FINAL REPORT – INSPECTION 2009-12910-01– PEER REVIEW OF STABILITY ANALYSIS OF DIKE C AT KINGSTON FOSSIL PLANT

Technical Rebuttal to May 11, 2010 TVA Response to OIG Draft Inspection
2009-12910-01 – Peer Review of Stability Analysis of Dike C at Kingston Fossil Plant

Tennessee Valley Authority Kingston Fossil Plant (KIF)
Harriman, Tennessee

Peer Review of Stantec Consulting Services, Inc.
Report of Geotechnical Exploration and Slope Stability for Dike C
Tennessee Valley Authority Kingston Fossil Plant (KIF)

Figure 1
Kingston Fossil Plant
Dike C - Station 154+00
Starter Dike

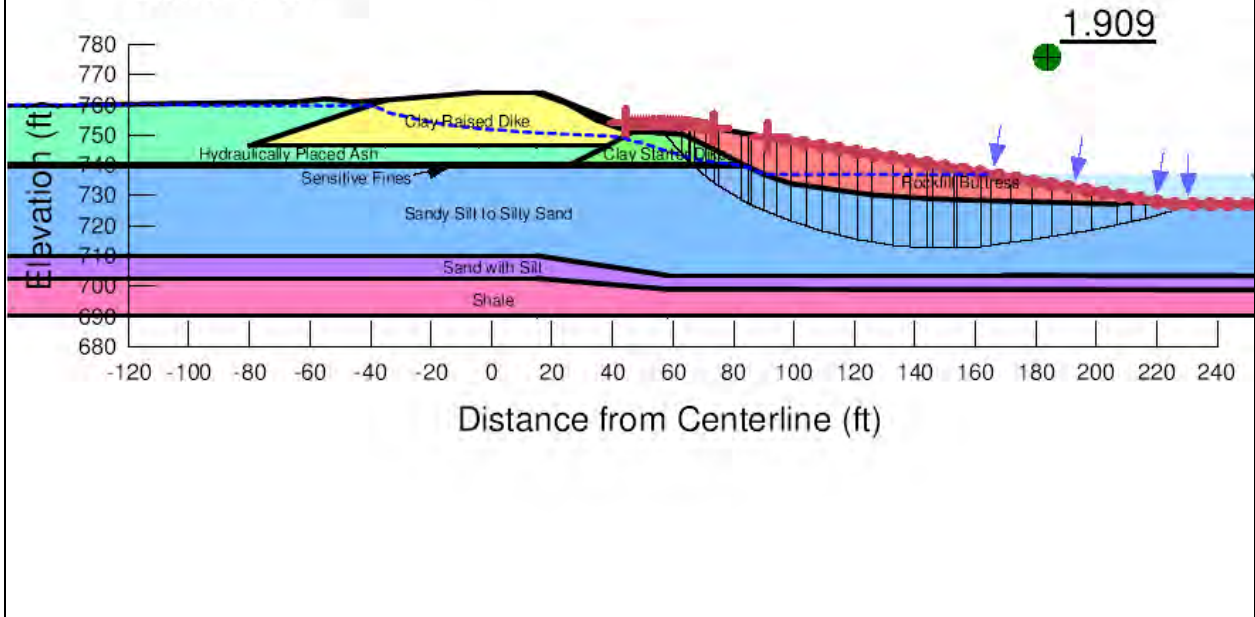
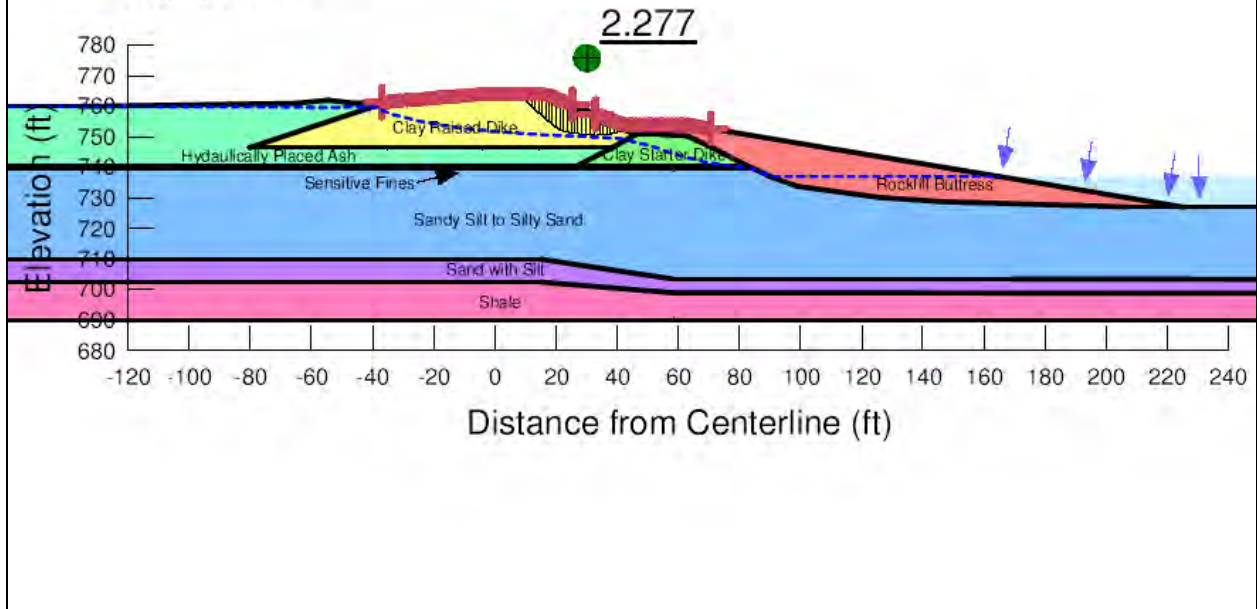
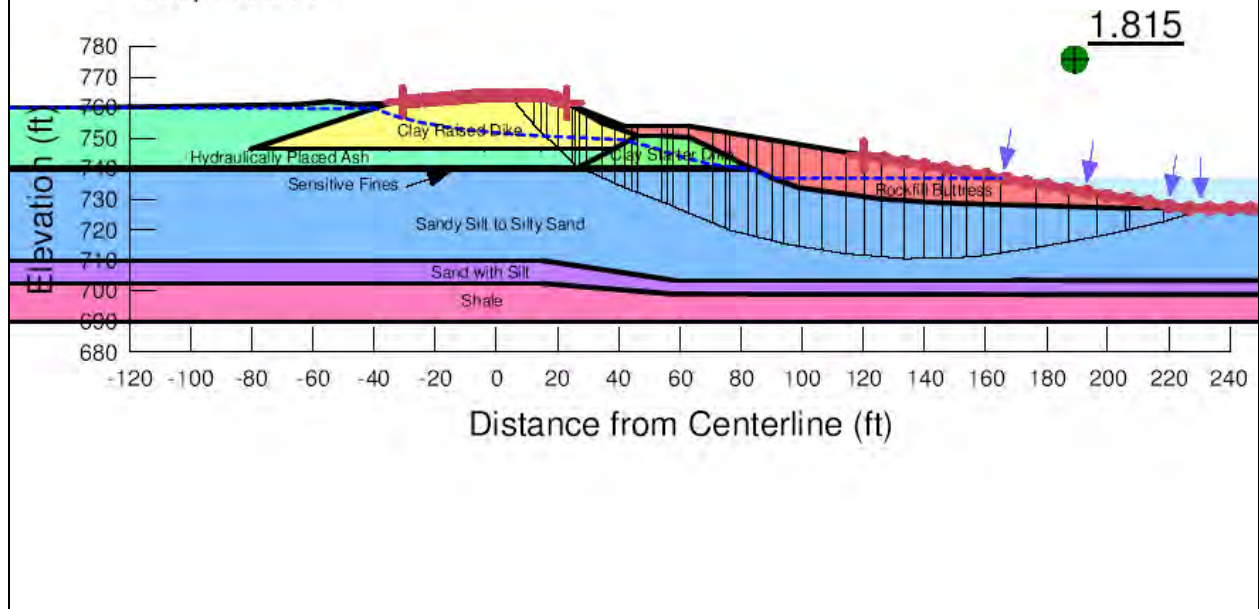
Comment 4:

The stability evaluation for the section at Sta 154+00 using the as-surveyed lake bottom geometry and with the buttress in place is shown on Figures 1 to 3 in Comment 4 Appendix with the results summarized in Table 4.2 below. This stability section was developed based on as-built surveyed ground geometry with subsurface soil conditions from the previously analyzed stability section at Sta 149+14. Using the same shear strength parameters and SEEP/W input file as outlined in Stantec's August 3, 2009 stability report, and under steady state conditions, the buttress design at this critical section satisfies the slope stability requirements, with Table 4.2 listing the estimated factors of safety for the various slip surfaces. The cross section at this location was also reviewed to ensure that the filter will provide an adequate factor of safety against piping. With the filter and buttress in place, the estimated factor of safety against piping is estimated to be 18.6 (Table 4.2) which is acceptable as per USACE 1110-2-1901.

Based on the referenced vibracore/bathymetric survey data, and results of the additional analyses performed for section 154+00, Stantec will continue to review as-built survey information as it becomes available and will continue to assess the adequacy of the designed mitigative measures against the actual conditions encountered. Further, Stantec will be completing an As-Built report upon the completion of the Dike C buttress construction to document that target factors of safety are maintained through implementation of the Risk Mitigation Plan.

Marshall Miller's comment is satisfactorily addressed by the additional information supplied with Stantec's response and the description of Stantec's and TVA's efforts to identify and address differing conditions during implementation of the Risk Mitigation Plan.

Comment 5 Appendix

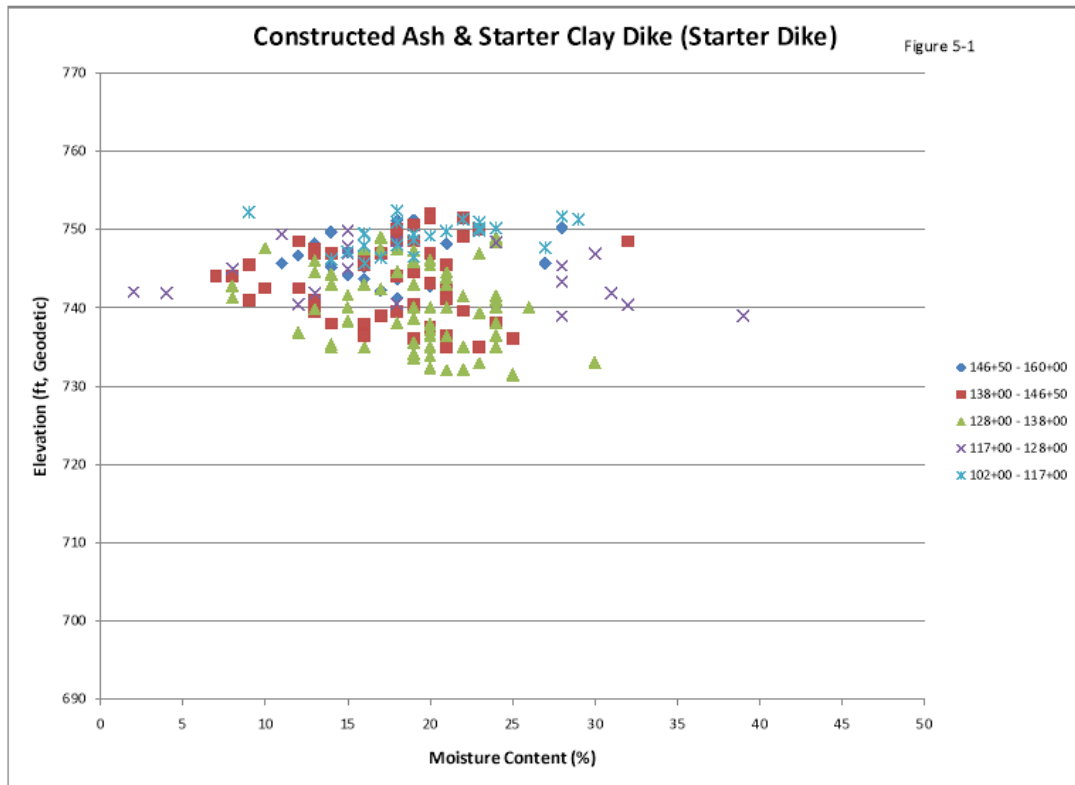
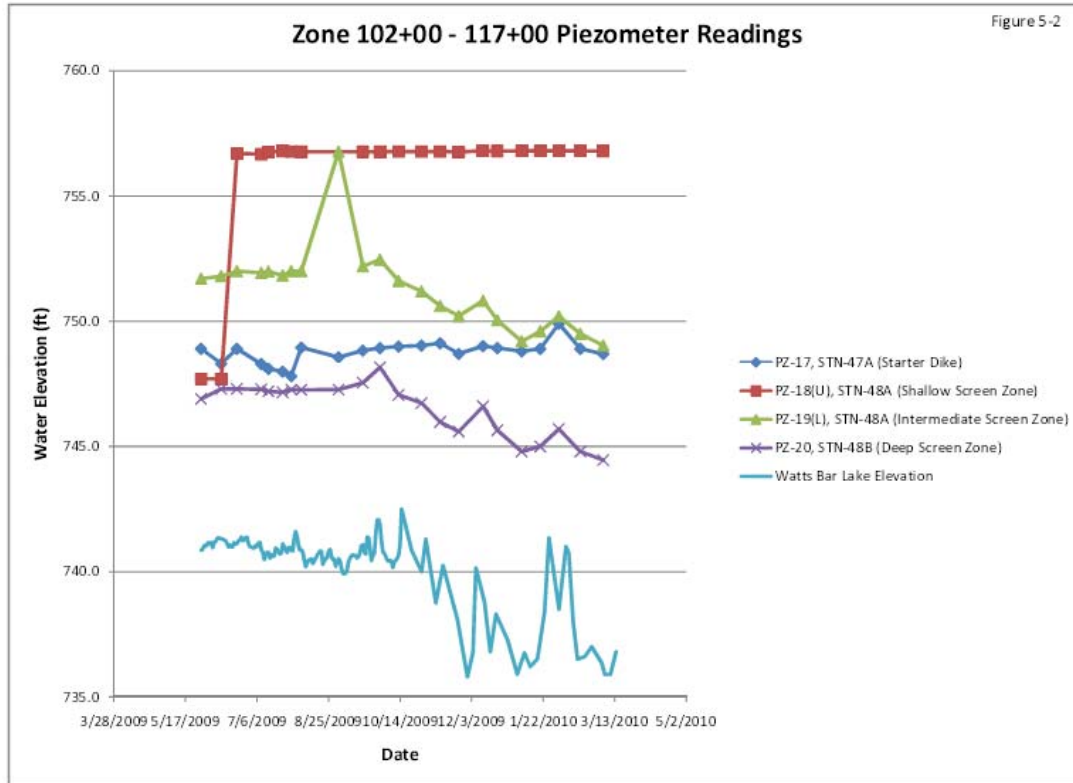
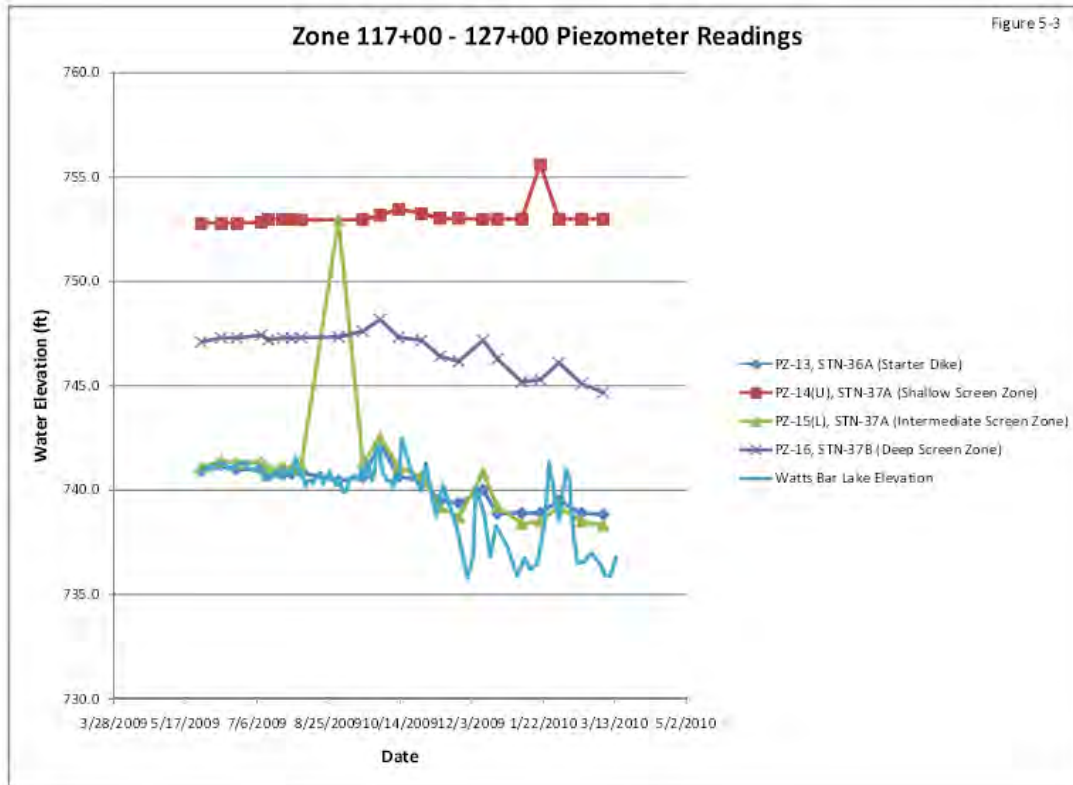
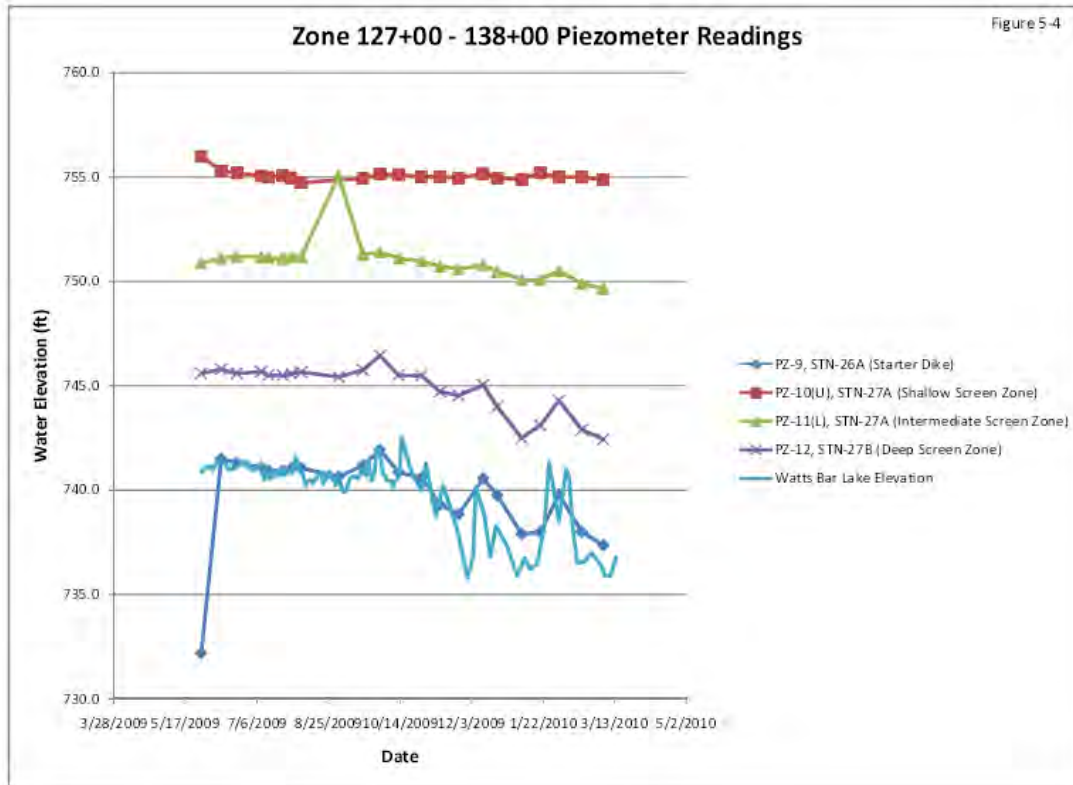
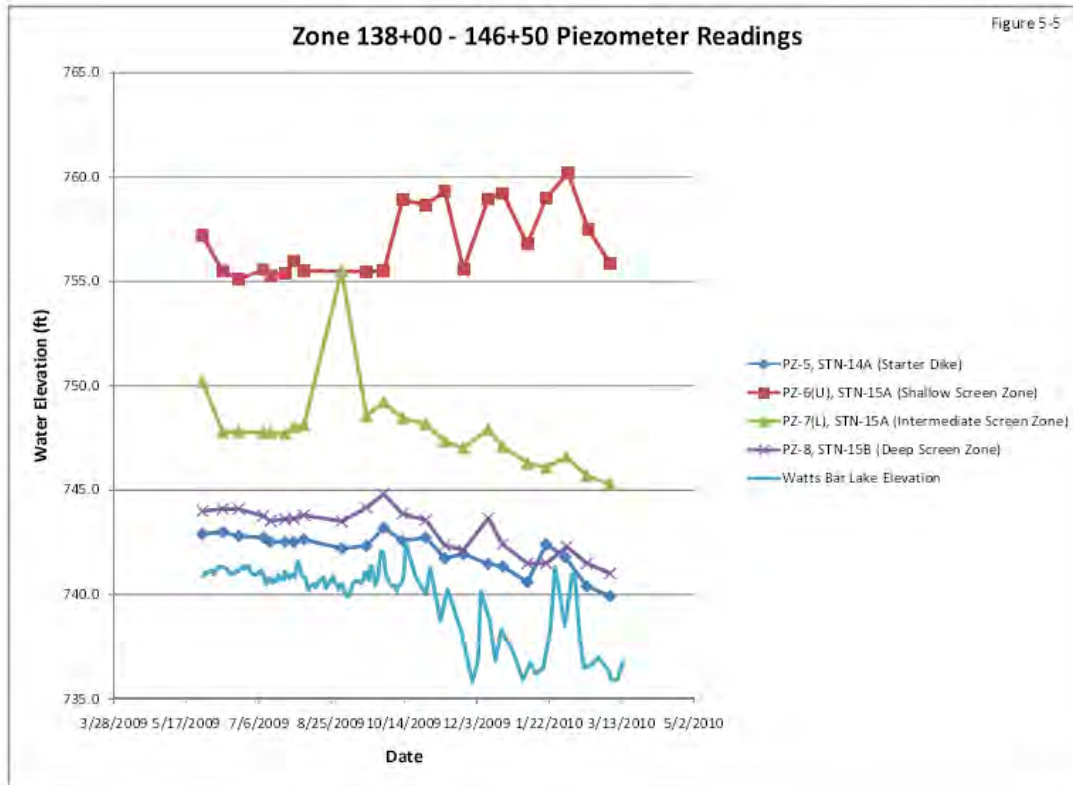
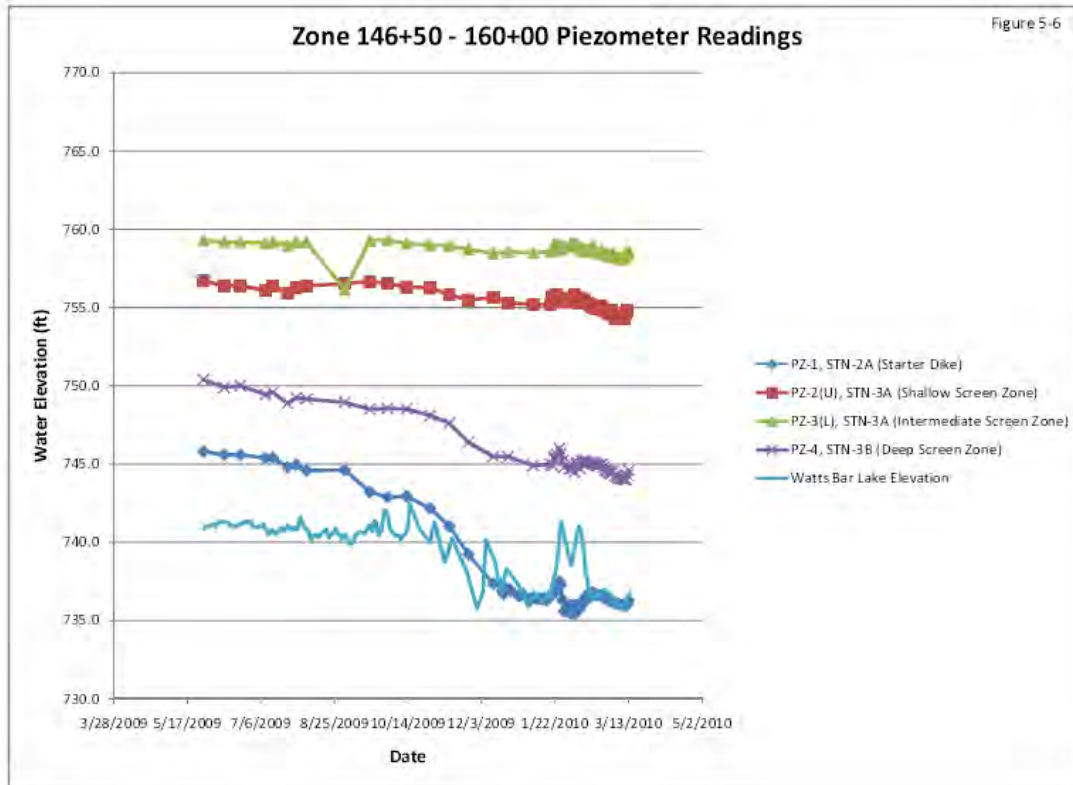
Comment 5:

Noted. The starter dike was originally constructed to an elevation of approximately 748 ft using residual clay and ash materials. In 1974, the starter dike underwent an interim raise of approximately 1.5 ft to provide additional freeboard capacity. From the borehole drilling, there was significant layering of various materials that makes up the starter dike as a whole, however, these layered materials showed reasonable similarity.

There were a total of 11 Atterberg Limit tests and 13 grain size tests performed on the constructed ash and clay materials that make up the starter dike. These tests were performed on samples taken from 11 boreholes along the top of the starter dike and are labeled as "Starter Clay Dike" or "Constructed Ash" materials in Table 5-1 in Comment 5 Appendix. From the Atterberg Limit Tests performed on starter dike materials, the liquid limit ranged from 23 – 44% (average 33%) with the plastic limit ranging from 14 – 26% (average 19%). The grain size of the material was similarly consistent and generally contained 0-30% gravel sized particles, approximately 30% sand-sized particles, 15 – 30% silt-sized particles, and 10 – 25% clay-sized particles. Moisture content tests from all soil samples taken from the starter dike materials are shown in Figure 5-1 in Comment 5 Appendix and show very consistent moisture content values at between 10 – 30%.

Marshall Miller's comment is satisfactorily addressed by Stantec's explanation and the additional information in the Comment 5 Appendix to Stantec's response.
